**LAWRENCE HISTORIC RESOURCES COMMISSION**  
**ITEM NO. 6: DR-15-00466**  
**STAFF REPORT**

DR-15-00466 1012 Massachusetts Street; Sidewalk Dining Railing; Downtown Design Guidelines Review. The property is located in the Downtown Urban Conservation Overlay District. Submitted by Vic Allred for Christie Brothers LLC, the property owner of record.

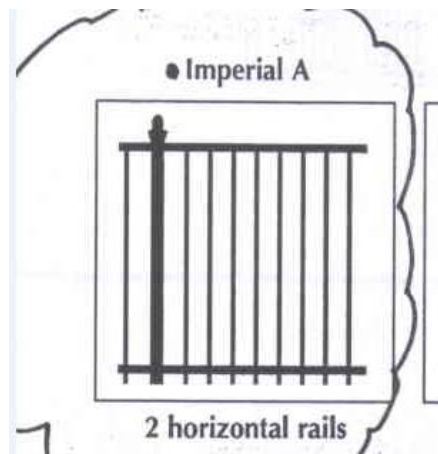
proposed and installed by the applicant is within the parameters of railing designs in the area. The design of the railing (see below) is not a concern for staff.

Of concern for staff is the addition of a large metal arch that will span the two areas of the existing railings. The arch is taller than the maximum height recommended for railings. While the arch is not the railing per se, it is the demarcation of the outdoor dining area. The proposed arch may be viewed as an entry feature to the dining area. This type of entry feature was not anticipated when the guidelines were adopted and are not addressed in the guidelines. The identified purpose of the railing height is to maintain maximum visual access. In staff's opinion, the height of the arch impedes the visual access to the building and to the views from both the north and south on the sidewalk. The height of the arch also impedes the visual access to the building and the architectural features of the building.

The height of the arch is a concern for staff, but the larger issue is the character of the downtown area. 4.4 of Section Three of the guidelines specifically state that railings and barriers shall reflect the character of the area. There are no arches of this type in the downtown area and it is not reflective of the historic or current character of the area. Staff is of the opinion that the arch will alter the character of the downtown area. The arch is attractive and may be appropriate in a different setting, but it is not compatible to Lawrence's downtown area.

In accordance with the *Downtown Design Guidelines*, the standards of evaluation, staff recommends the Commission deny the proposed project and make the determination that the proposed project does not meet the intent of the Downtown Design Guidelines for the Downtown Urban Conservation Overlay District. As proposed, the project does not meet the following guidelines:
